## **ADDENDUM NO. 1**

**DATE:** March 15, 2019  
**FROM:** City of Grand Junction Purchasing Division  
**TO:** All Offerors  
**RE:** The Riverfront at Dos Rios Business Park Phase I IFB-4616-19-DH

THE RIVERFRONT AT DOS RIOS  
SANITARY SEWER PLAN AND PROFILE

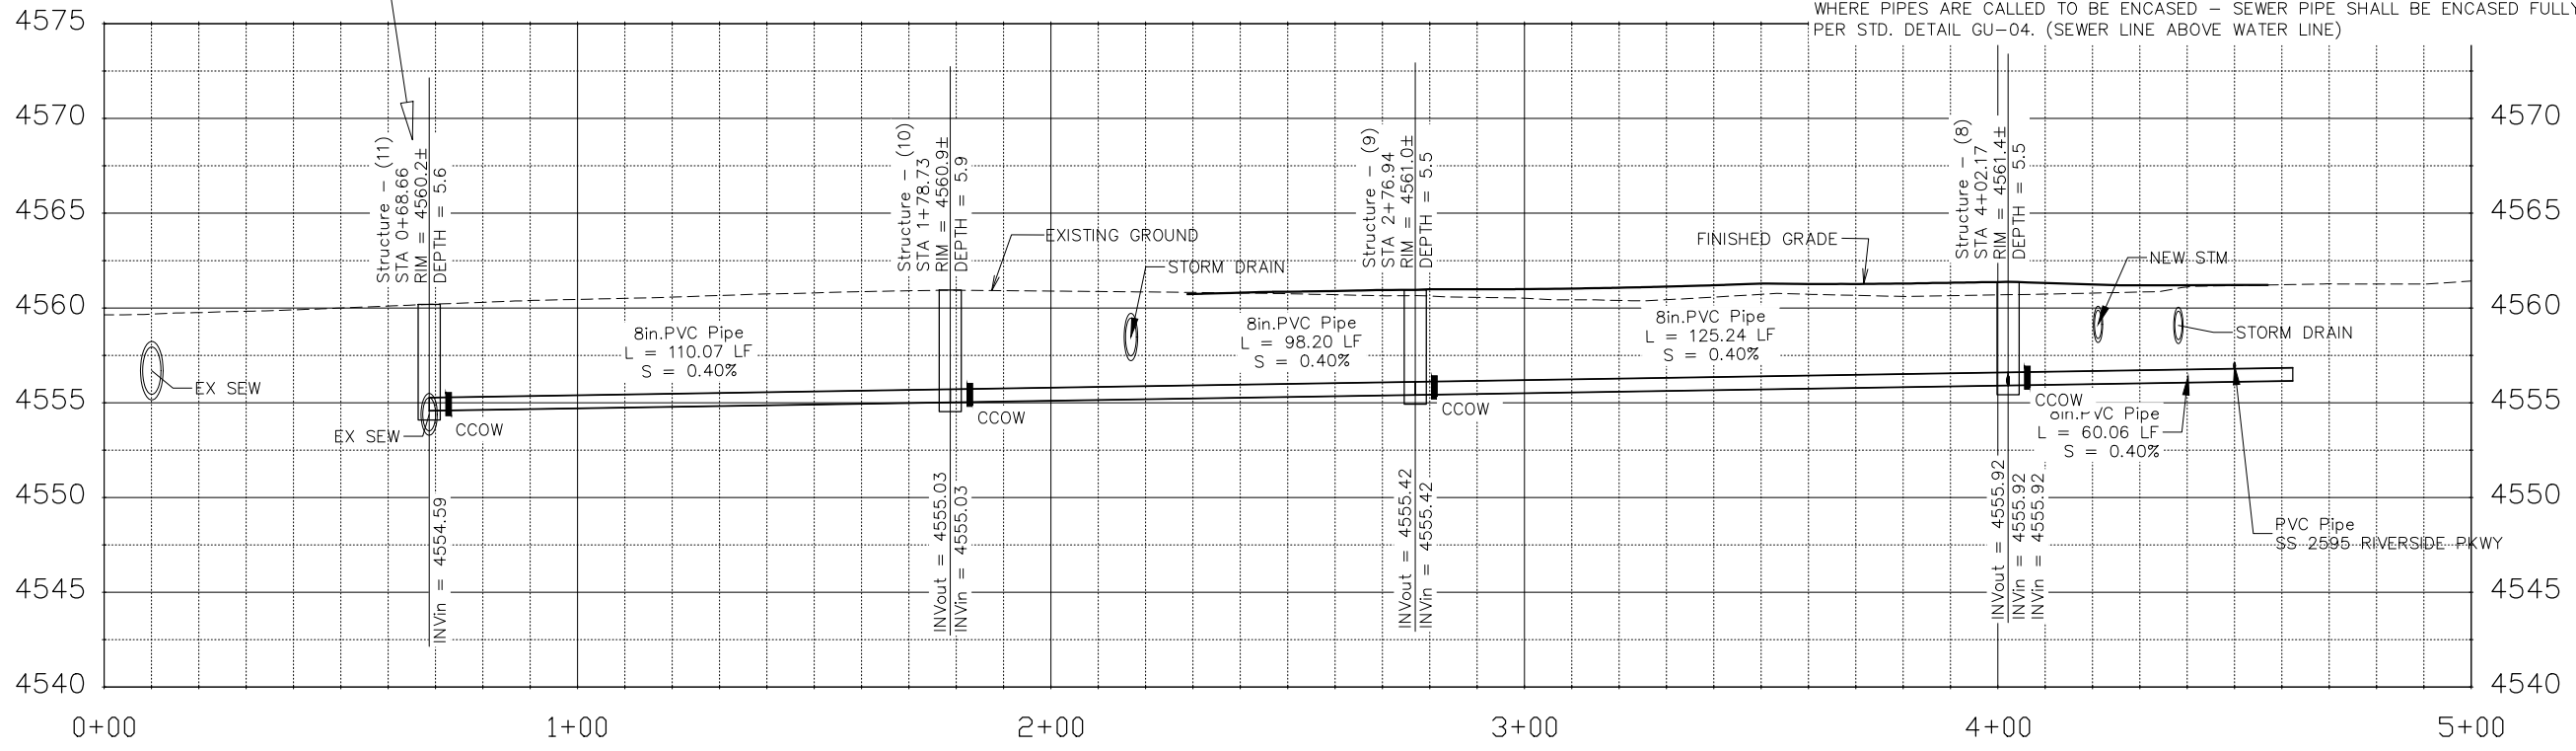
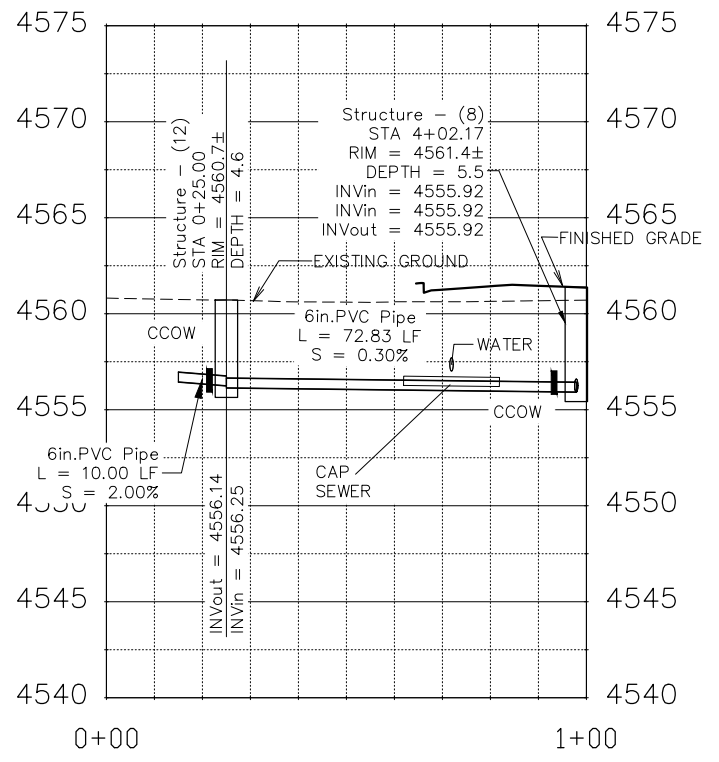
4. Clarification has been made regarding the sanitary sewer service pipe size, and is reflected on sheets 6 & 7 within the updated construction plan set.

REVISION	DESCRIPTION	DATE
REVISION Δ	SEWER SERVICE SIZE CLARIFICATION	3/14/19
REVISION Δ		
REVISION Δ		
REVISION Δ

▲ ALL SEWER SERVICE LINES SHALL BE 4" SDR-35 PVC

THE RIVERFRONT AT DOS RIOS  
SANITARY SEWER PLAN AND PROFILE

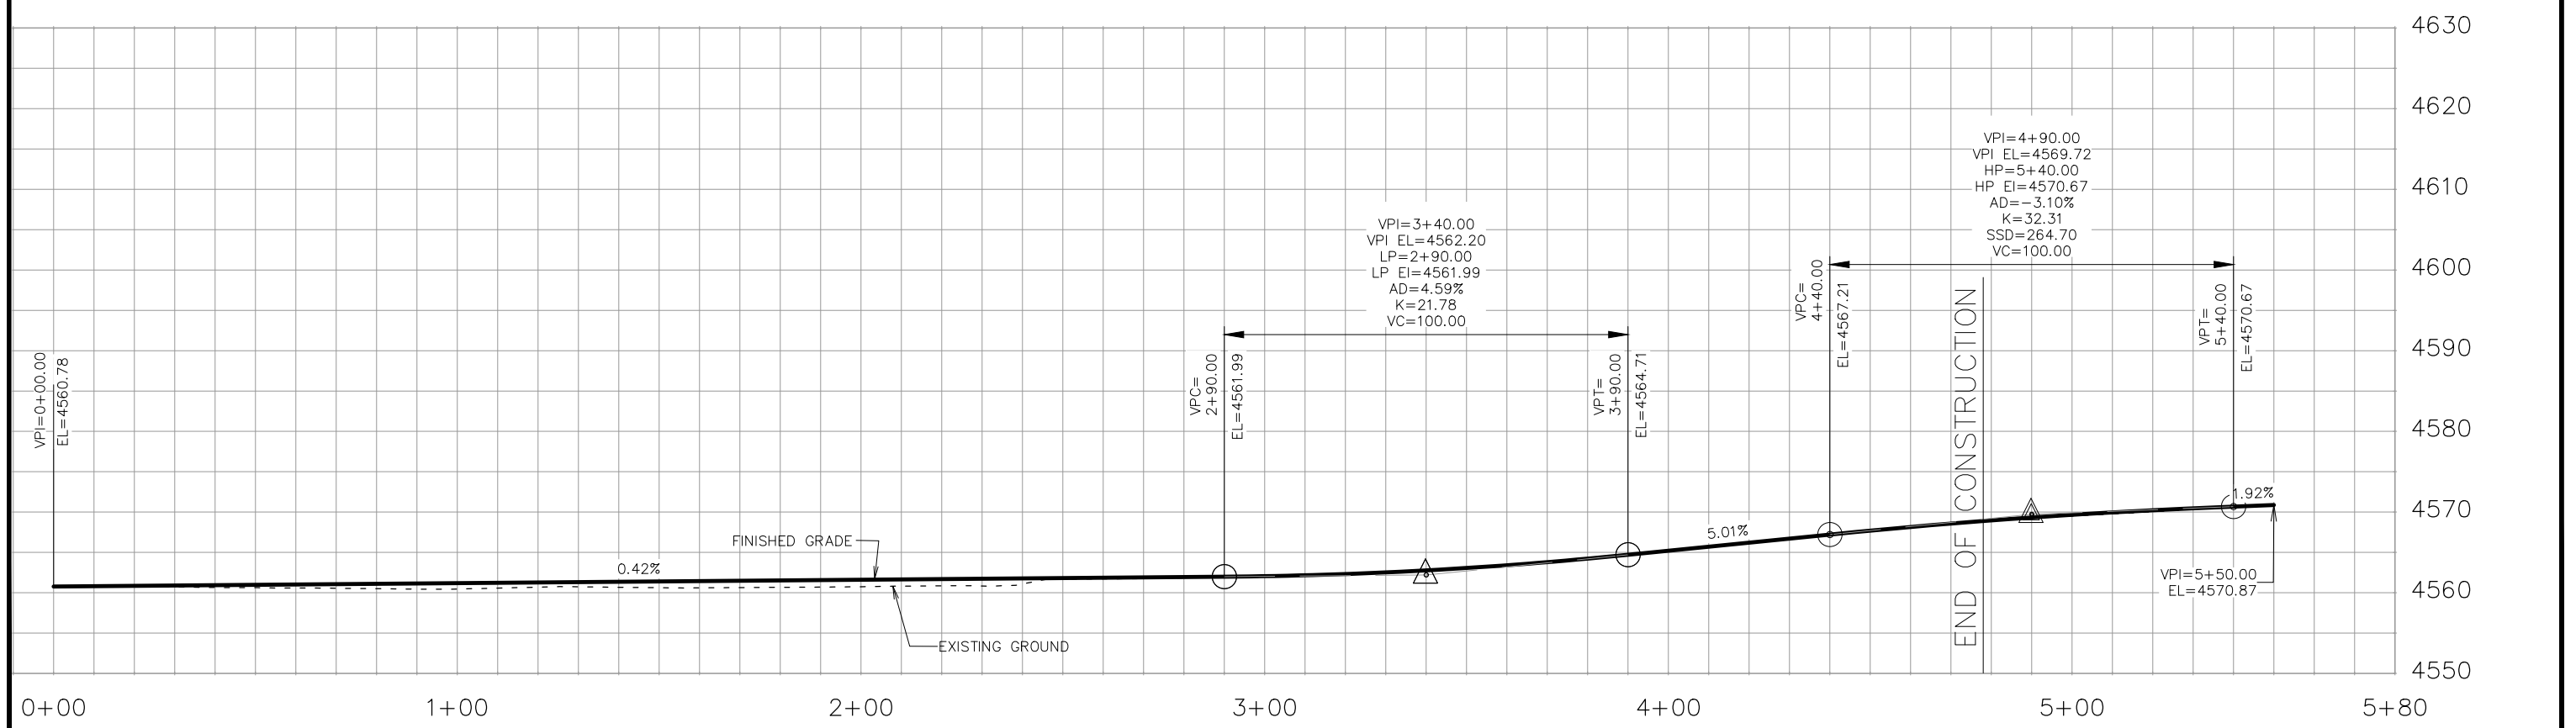
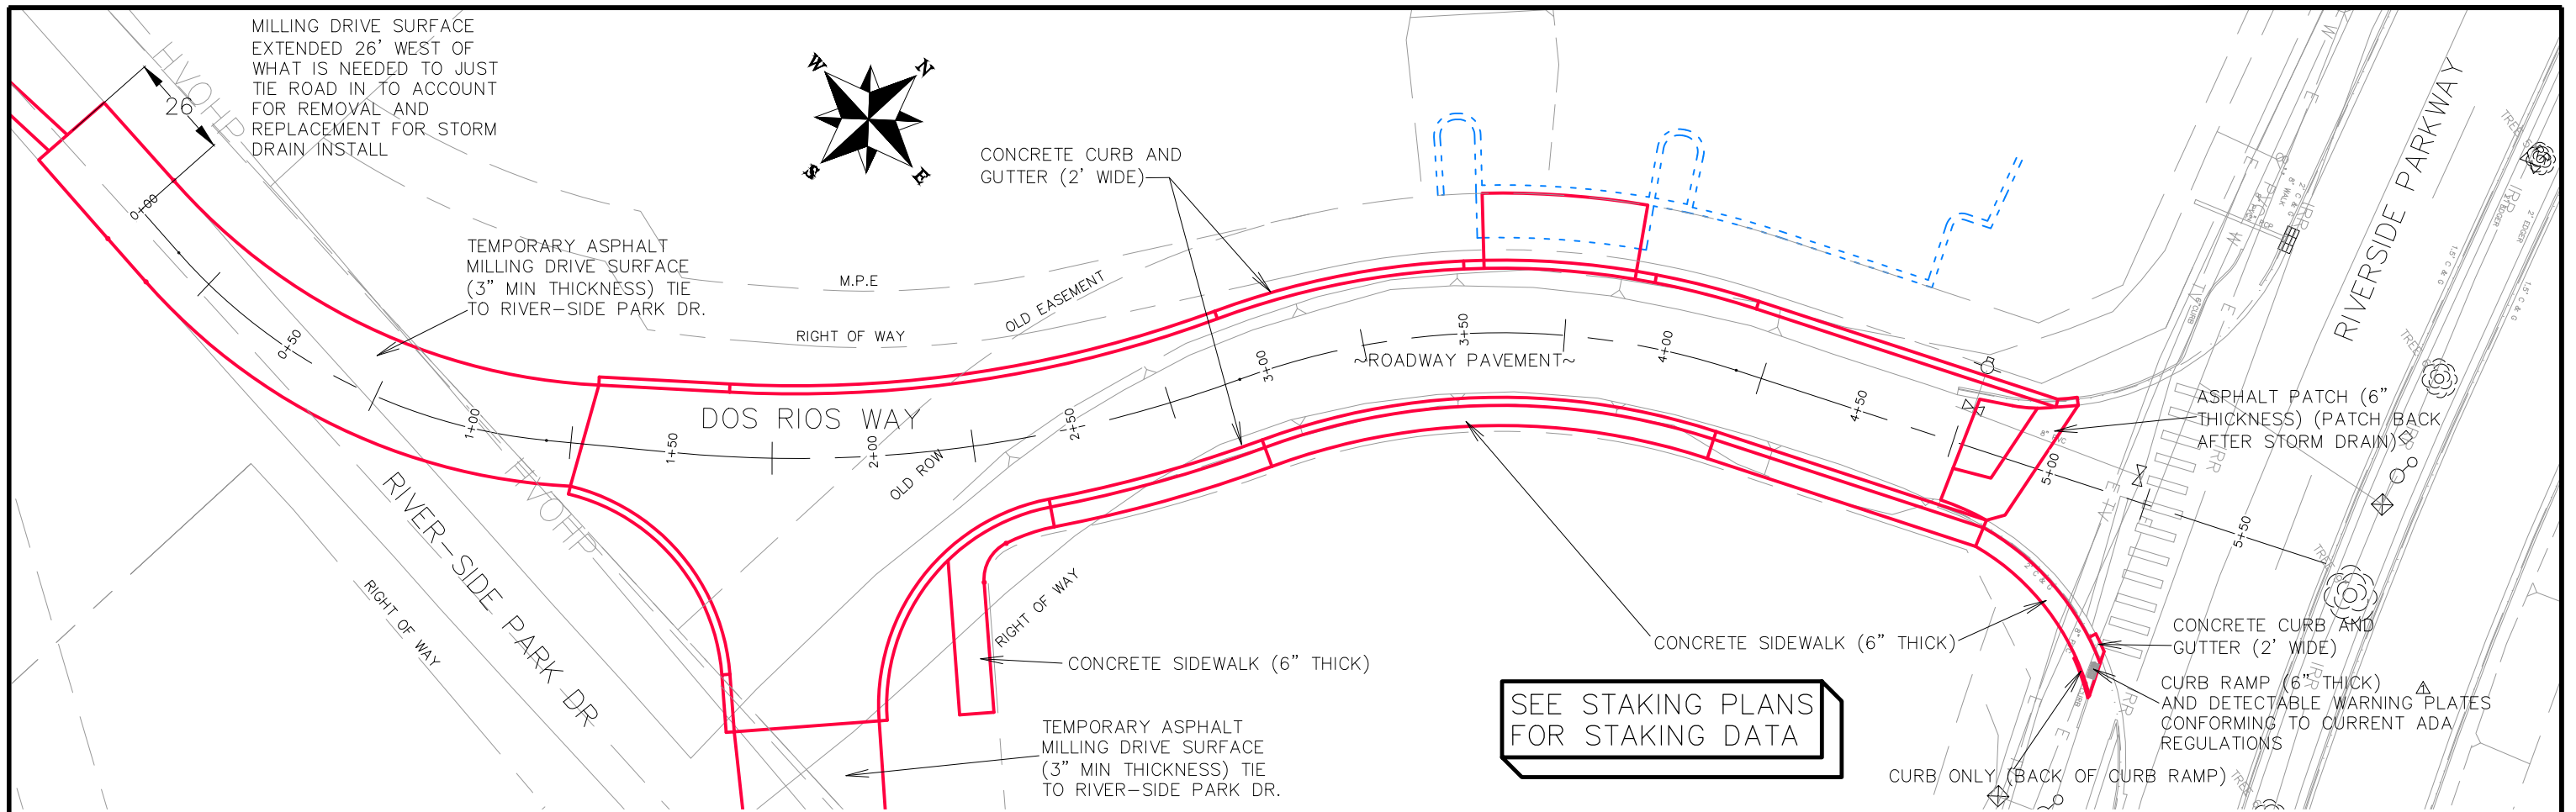
REVISION	DESCRIPTION	DATE
△	SEWER SERVICE SIZE CLARIFICATION	3/14/19
△		
△		
△

**TYPICAL COMMON TRENCH DETAIL PROPERTY SIDE**

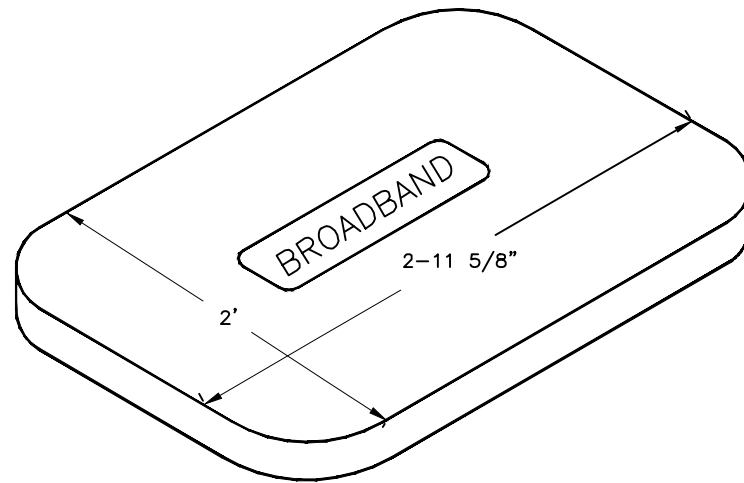
6. Item(s) 46 through 49 on the attached Bid Schedule represent the quantities for the different sized conduits to be placed in the joint utility trench. See utility trench detail on sheet E9 of the attached Site Lighting/Electrical Plan set.
